Product Change Notification

PCN-20240422.1.HFX

Description of Change: Tool Update

CI08-AM4

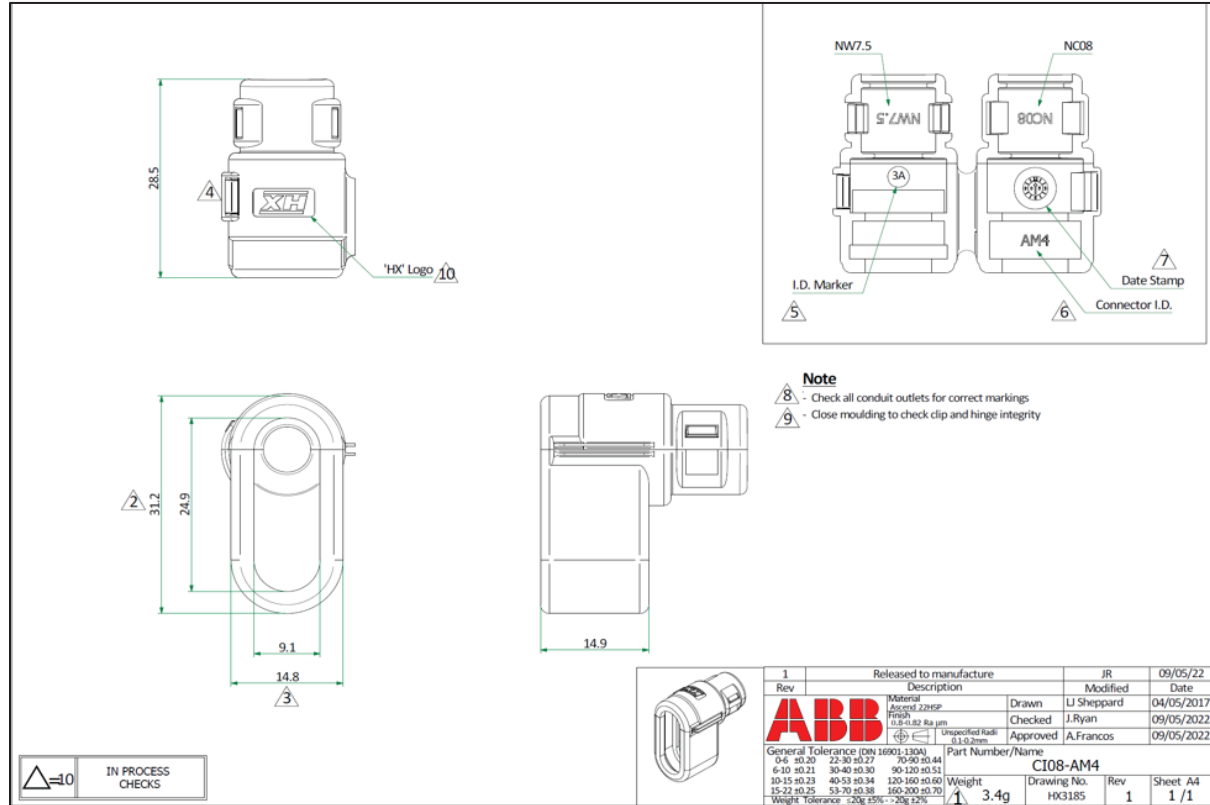
An opportunity has been taken to improve previous product design to ensure that they are in line with our current product designs of Connector Interfaces. We have introduced better hinge and clip features to improve the performance and reduce the overall length.

There are minor variations in dimensions and markings of the finished product produced on the new tool, these are detailed in the attached drawings.
